Hamilton City Council
Development Engineering Unit

ACCEPTED ENGINEERING PLANS

19-30410-01-LUK - CHEDWORTH - AREAS L, U & K - STAGE 24 (GREENHILL PARK) ENGINEERING DESIGN

Number	RFI	Recommended Resolution	S&L Comment	Comment	HCC COMMENTS 11/04/2025	S&L Comment.	HCC Comments 24/04/2025	S&L comments	HCC Comments 05/05/2025	HCC Comments 07/05/20252	S&L comments 06/05/2025
Table 1 – General observation/recommendation	The overall level of detail in the documentation isn't considered to be of sufficient detail to support an EPA design.										
T1.1	Detailed calculations supporting the design are incomplete. Overall, there seems to be significant reliance on conceptual work undertaken by Beca to support the CDP. It is expected that all design calculations would need to be revised to support an EPA design.	Resolution of specific items are included in the tables below. However, it considered that the application should be supported by a more comprehensive stormwater design document – ideally a Water Impact Assessment (WIA) prepared for this stage of development.	The Beca reports utilised for this design: - Beca Infrastructure report 2016 - Beca WIA 2016 - Beca SW Design report, 2016 Wit

SWALE - WEST
PLAN AND
LONG SECTION

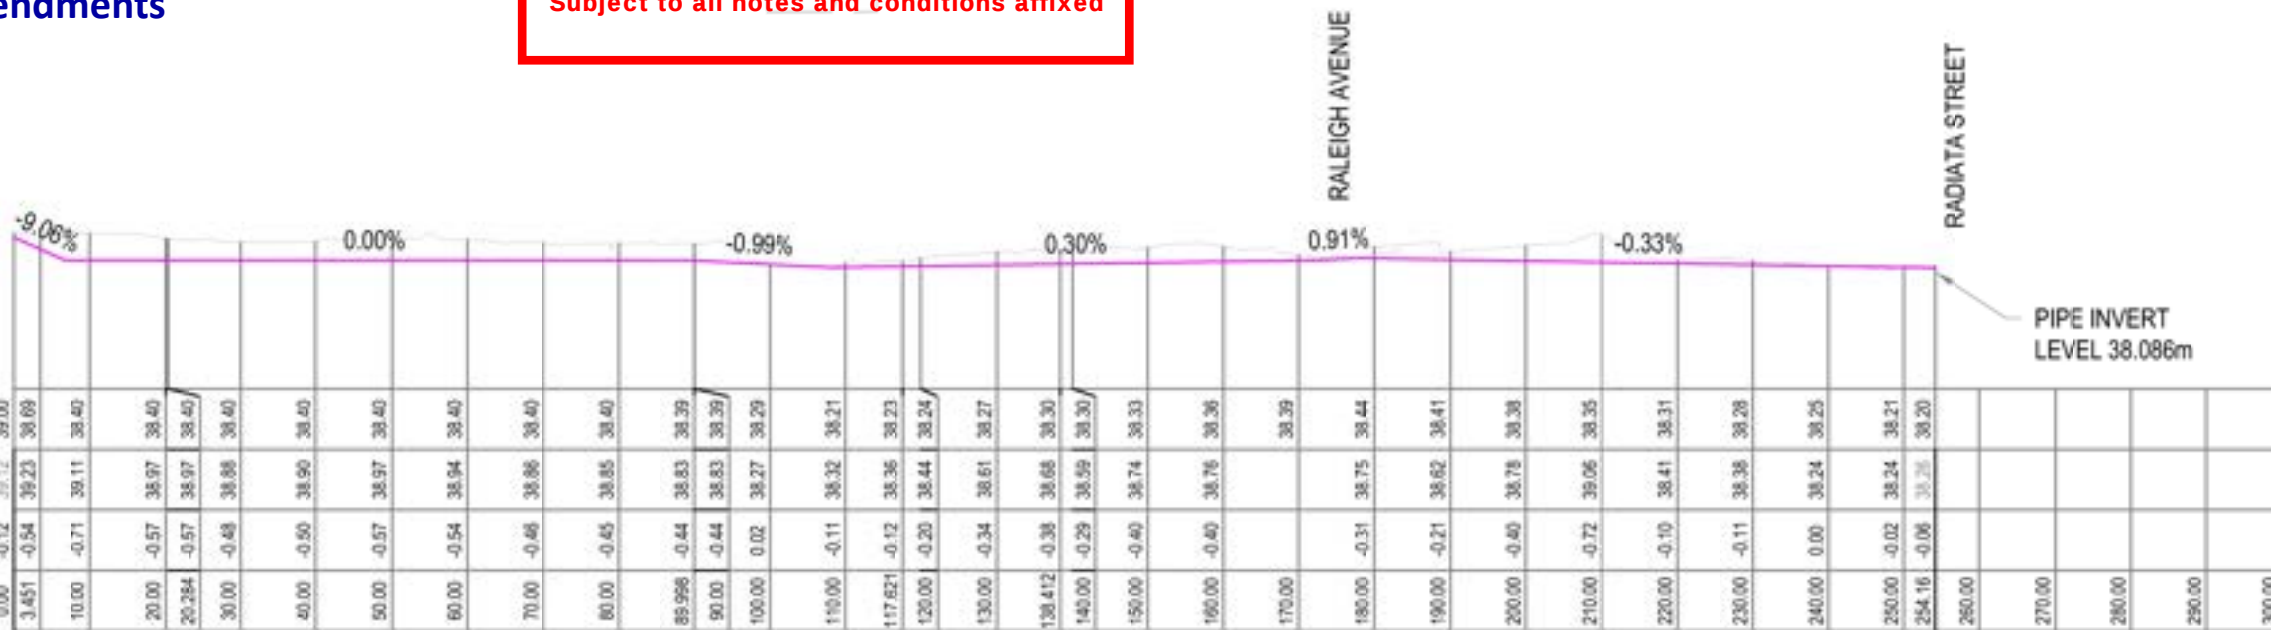
TS 27							Western Boundary Swale Drawing R18 shows the swale west long section. The swale has been designed longitudinally flat from CH10-CH90. This channel needs to have positive fall to avoid significant surface ponding. We acknowledge this was not picked up previously. We also recommend that the full length of the western swale is constructed with underdrainage (required under RITS Table 4-28). Closed for EPA. With construction of the swale base for chainages 10 to 90 of 0.3% falling southwards. Construction for the full length of the western swale to also include underdrainage.
TS 28							Footpath linking Radista to Webb has been removed from Drawing SW1? Closed for EPA. Radista footpath shown on roading set and will be constructed. Post construction review will be undertaken to confirm footpath link provides a sensible connection to Webb Drive. To be constructed to accessibility standards, a second more direct link with stairs may be required.

DRAWING NO
30410-01-S24-SW1

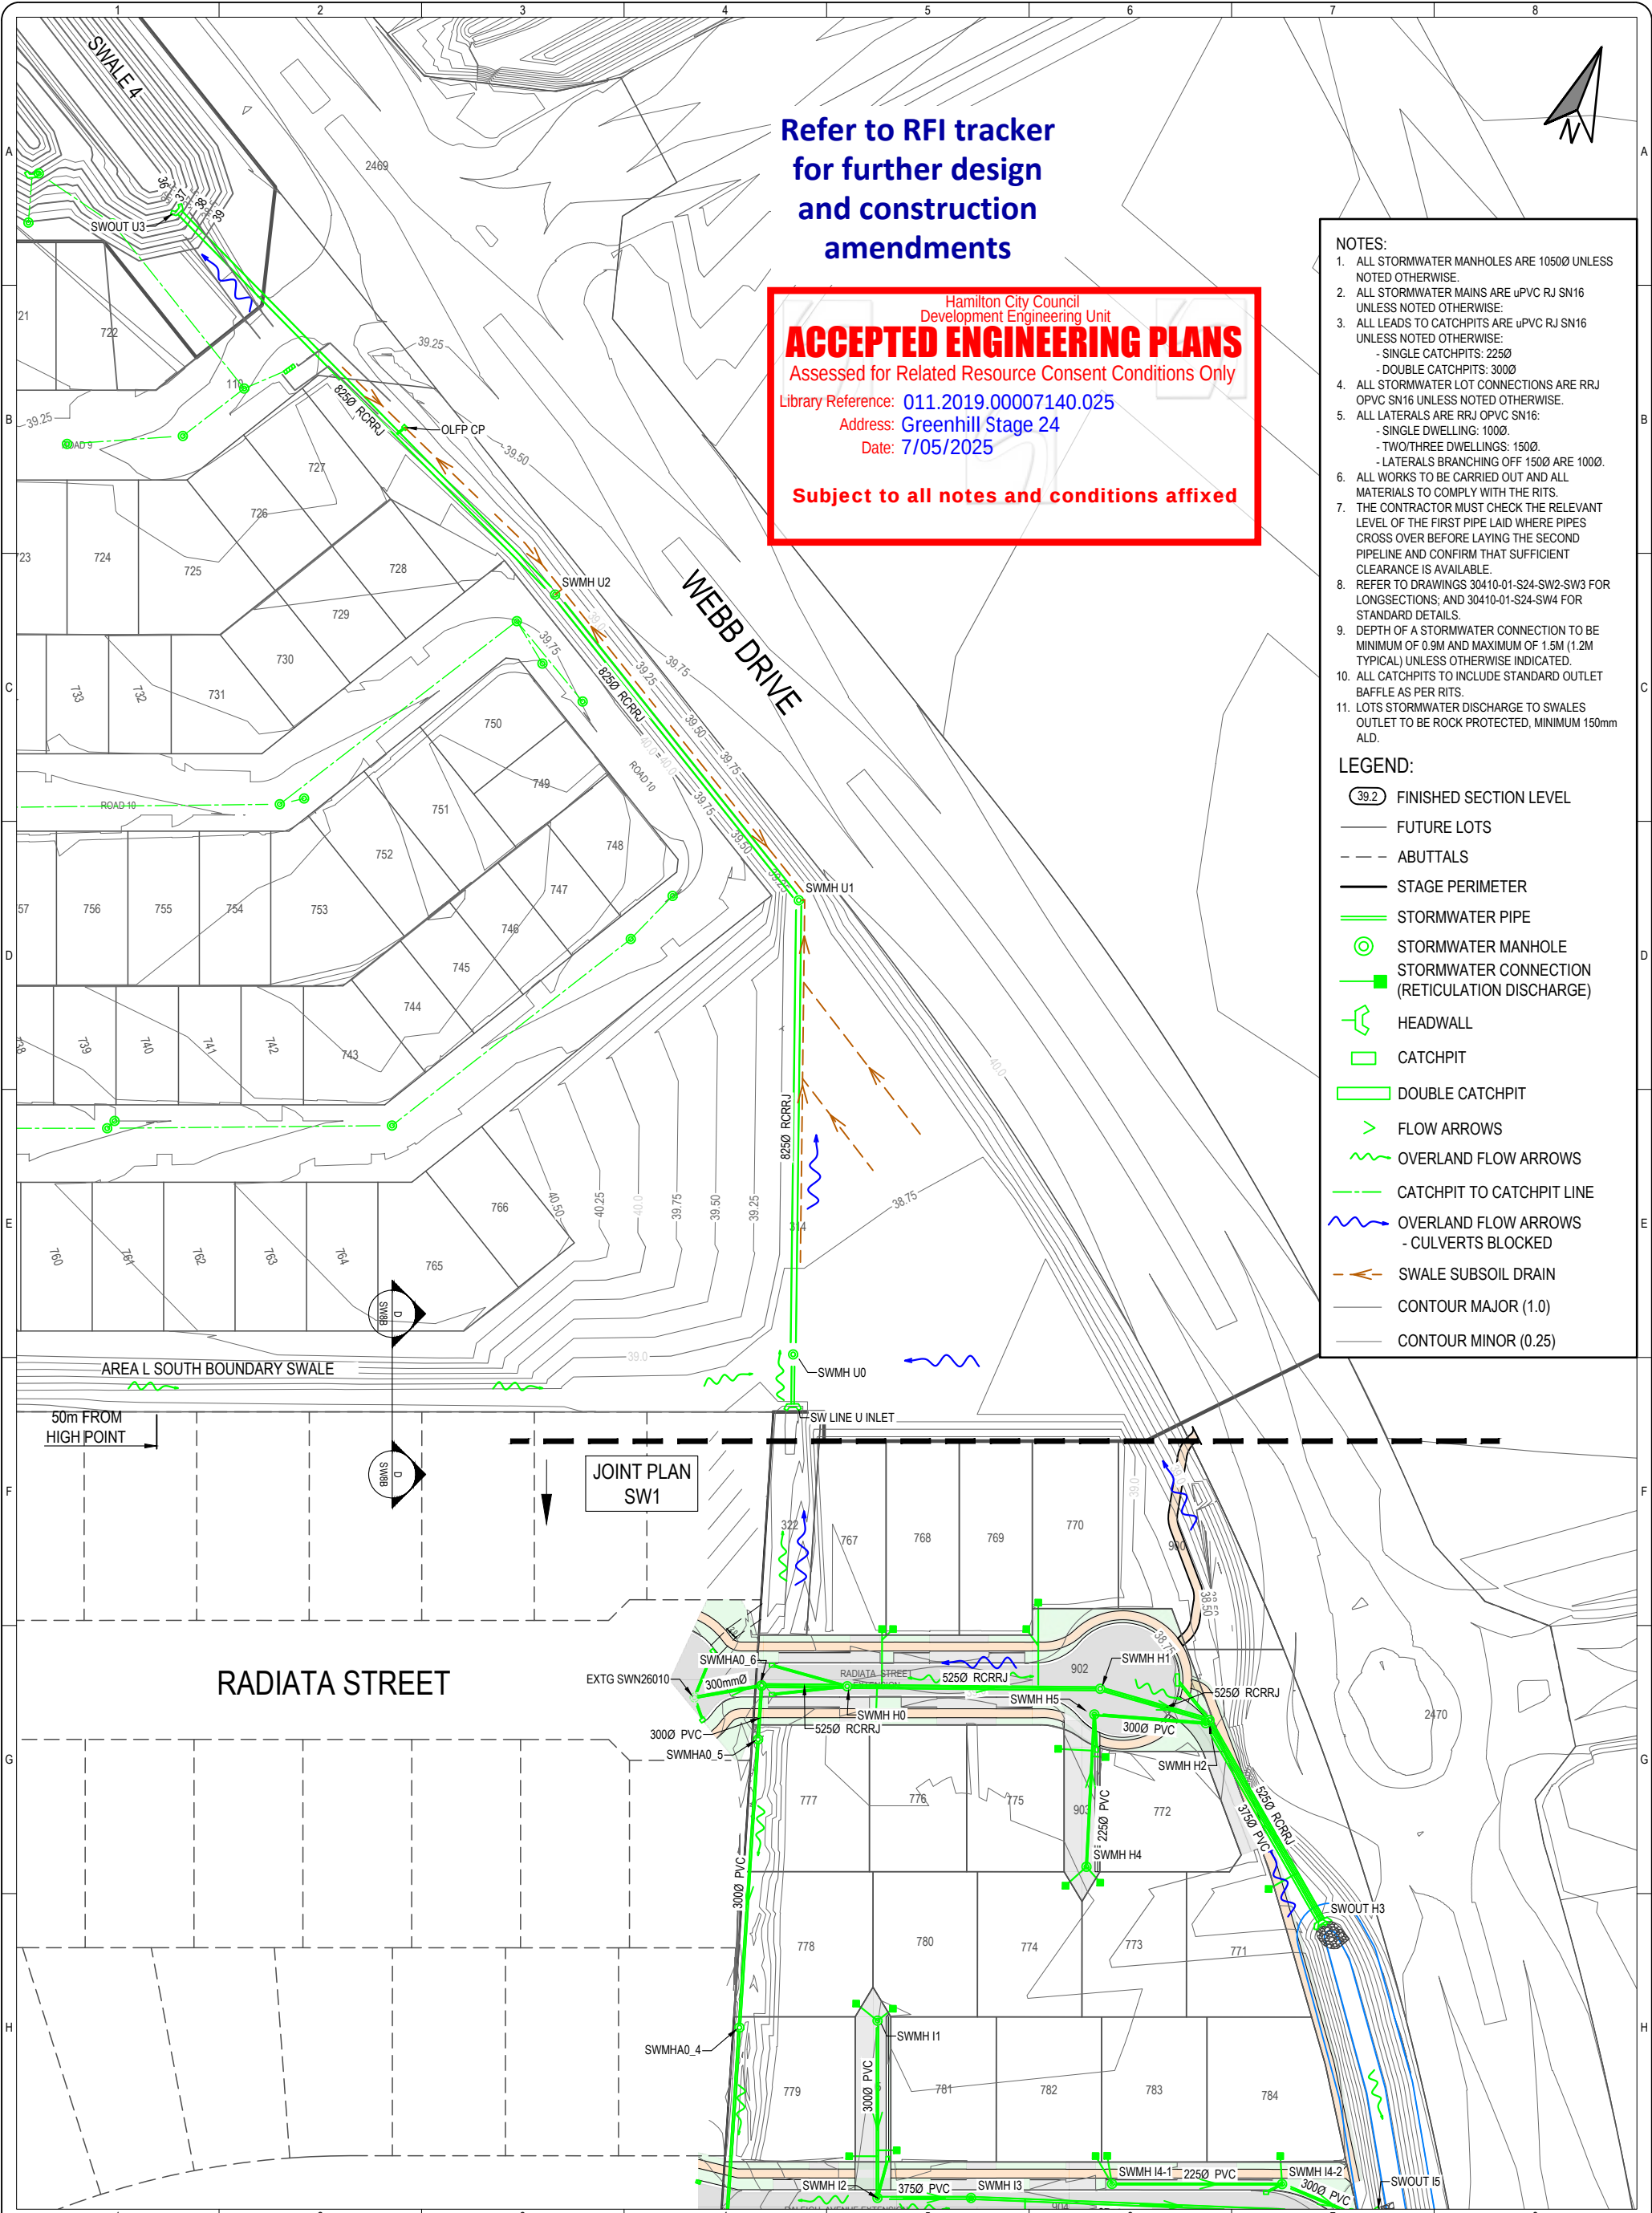
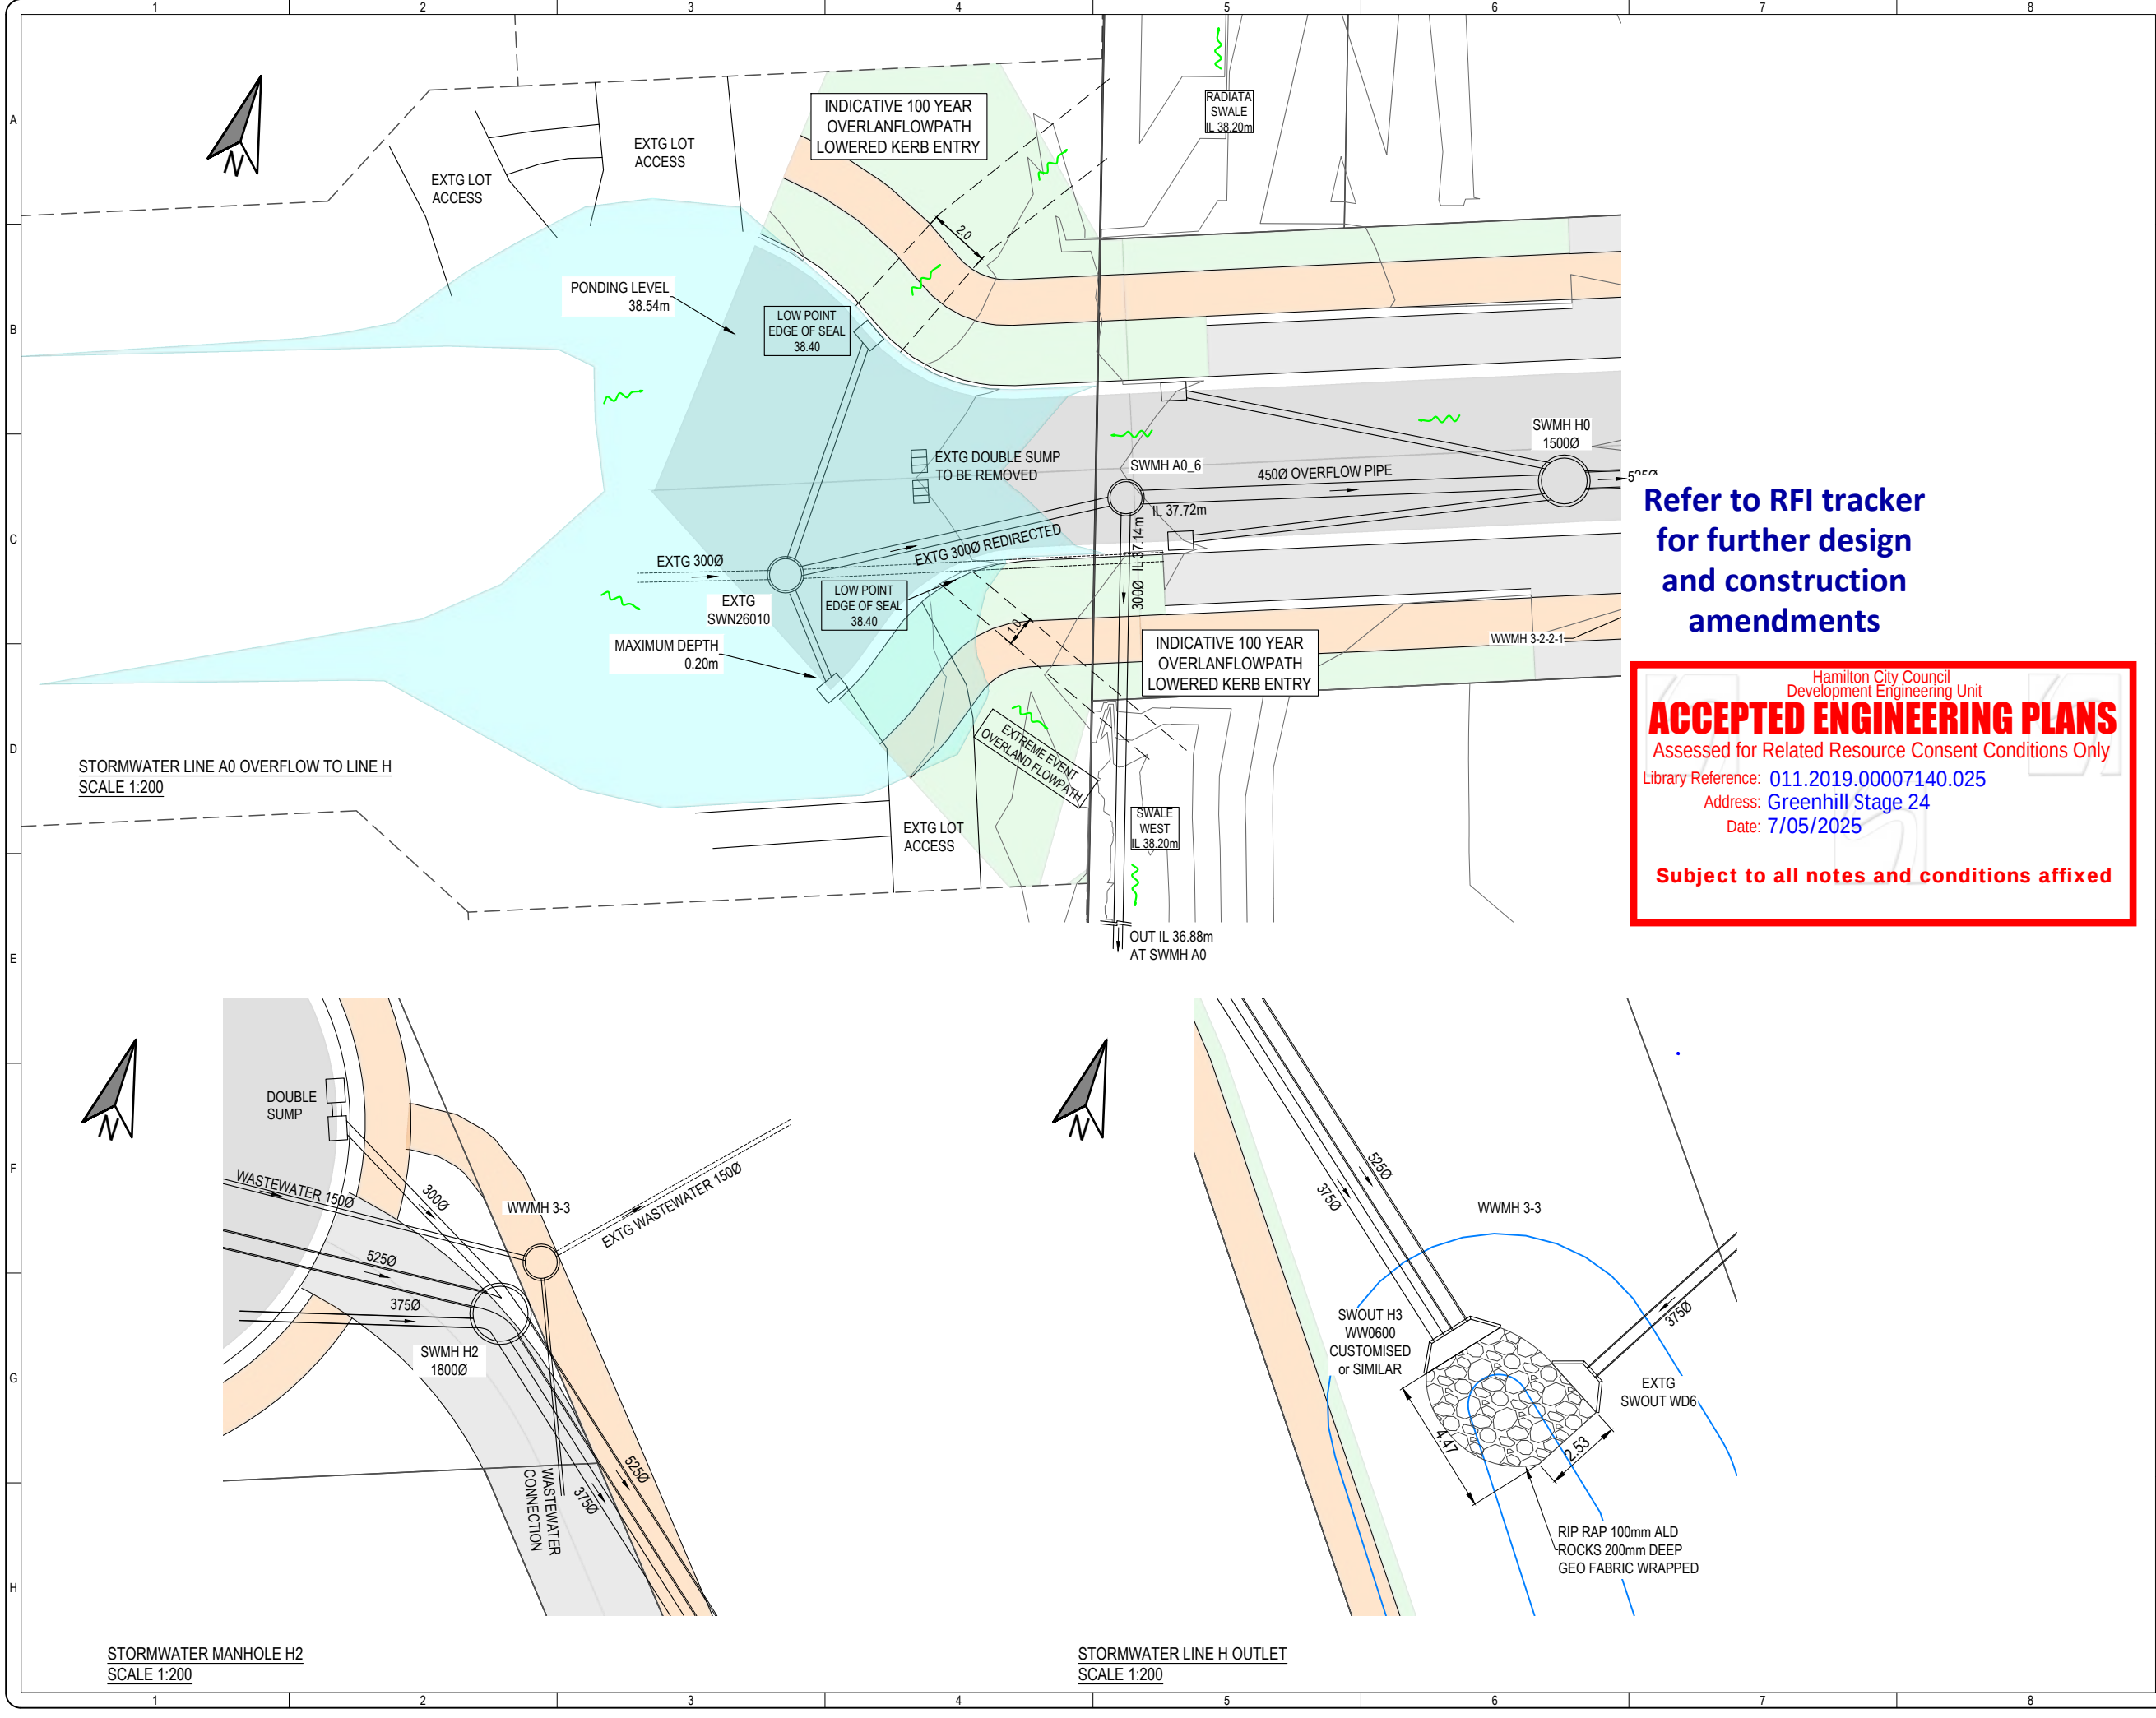
TS.8	Not clear why there is a different approach to SW network layout for the two ROWs – one has a central SW line with lateral connections, the other doesn't		Design is to manage SW capacity constraints.	Complete. Refer drawings SW1 & SW1A.	Accepted					Closed by HCC on 11/04/2025.
TS.9	The SW layout plan indicates that western part of Raleigh Ave is not captured by the reticulation network & discharged to Swale 6C – i.e. is not treated.		Correct. Due to the need to increase the elevation of the lot levels, the road needed to increase in grade. This means a small area of Raleigh Street (extension) will fall to the west.	Complete.	Refer further comments below					Closed for EPA. Covered by actions below.
TS.10	In some locations there are catch-pits connected to catch-pits, rather than laterally connected to a manhole. Location of Jacques southern catchpits in vehicle crossing.		Correct. This has been previously discussed and agreed with HCC in the previous RFI processes. SW design is constrained by the achievable fall.	Complete. Refer drawings SW1 & SW1A.	Accepted			Noted, and responded to below:		Closed by HCC on 11/04/2025.
